**Project #19-004
Meadow Creek Subdivision
Located at 2200 South 1400 West**

Project Name: Meadow Creek Subdivision
Proponent/Owner: DHI Builders LLC / Visionary Homes LLC
Project Address: Approximate 2200 South 1400 West
Request: Subdivision Permit
Current Zoning: MR-9
Date of Hearing: February 14, 2019
Type of Action: Quasi-Judicial
Submitted By: Russ Holley, Senior Planner

RECOMMENDATION

MASTER PLAN

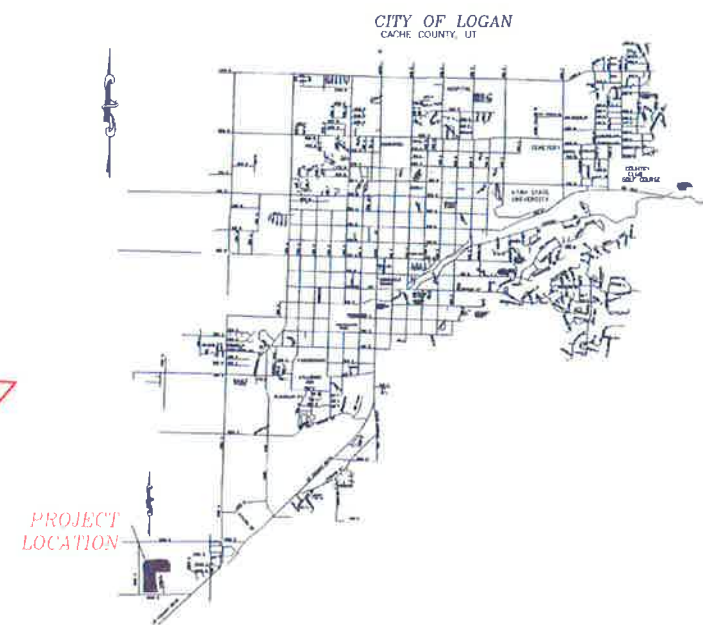
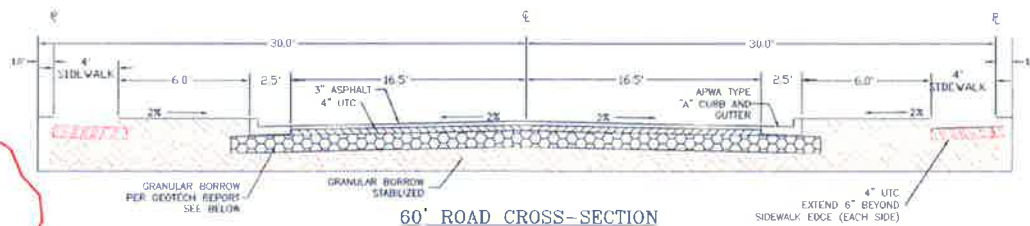
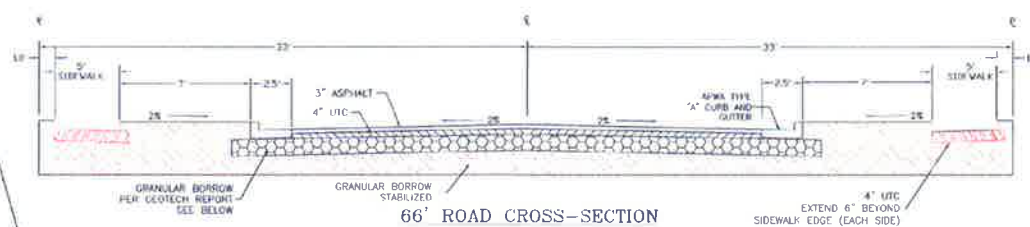
- a. *Environmental—contact 716-9760*
 - It appears the three cul-de-sacs on the north side are too small to allow the large collection trucks to safely maneuver so residents will need to either bring their containers to the main road for collection or line them up in the entrance. Residents on the small lane in the south west corner will also need to bring their containers to the main road for collection. An all-weather turn around must be provided at the end of each of the temporary dead-end roads during the construction phases.

- Develop all road improvements along 1600 West and 2200 South. Must provide a 24' width minimum pavement width on 2200 South and 1600 West for subdivision access for emergency vehicles, maintenance/service vehicles and resident access.

- Subdivision site plan shows the existing canal running through the middle of proposed lots. Per City standards the canal shall have a 15' easement from the top bank of canal along each side of the canal. If canal is to be relocated and/or piped this shall be done with the approval of the canal company. All storm water discharges to the canal shall also have canal approval.

- If second access from the subdivision (see Fire Dept comments) is to 1600 West, it also shall be reconstructed to accept 2 lanes of traffic with a shoulder per City standards. Johnson Ridge Lane cannot be used as the secondary access from this development per previous CAMP approvals (Spring Creek Village Subdivision).

- The pond located on the open space portion of the development is part of the canal system. Access along canal and pond shall be maintained. Record all easements along the canal and pond and all access easements to canal and pond on plat.

- All roads accessing subdivision from 2200 South or 1600 West shall be a minimum 66' wide.

- Approved fire apparatus access roads shall be provided within 150 ft of every portion of every building as measured by an approved route around the exterior.
- Approved fire hydrants shall be provided within 600 ft of every portion of every building as measured by an approved route around the exterior.
